## Planning Application APP/2015/1107

## Erect 66 Houses at Bogbeth Road (Land East Of Greystone Road), Kemnay.

At our Council meeting on 24 September 2015, the above application was discussed further with particular regard to the additional document submitted by Fairhurst and entitled "Transportation Statement".

Fig. 1.

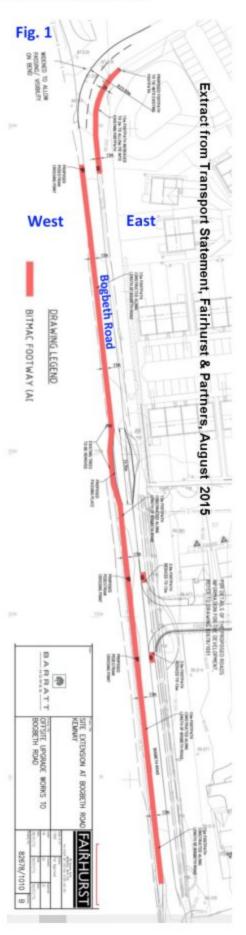
1. We generally welcome the revised proposals to provide a footpath along Bogbeth Road as shown in Drawing 82678 / 1010 B (Appendix C, page 31), see Appendix below, Fig. 1. However, we fail to comprehend the reason for providing the footpath on the west side of Bogbeth road instead of the east side? This revision necessitates crossing Bogbeth Road to use the footpath regardless of intended destination. If the footpath was on the east side of Bogbeth Road, Kemnay Academy pupils would not have to cross the road at all, but just continue along the footpath to join up with the existing footpath which presently terminates at the car park opposite the Skate Park.

The situation is however somewhat confusing when reading para. 4.2.3 on page 11, which states that "there will be a 1.5 mtr. footway implemented along the west perimeter of the housing developments on the <u>east</u> side of Bogbeth Road which would merge with the existing provision further north". This conflicts with Drawing 82678 / 1010 B which shows the footpath on the west side of Bogbeth Road, see Appendix below, Fig. 1. This situation requires urgent clarification but in the interests of safety, and creating unnecessary road crossings, we would like to see the footpath constructed on the east side of Bogbeth Road.
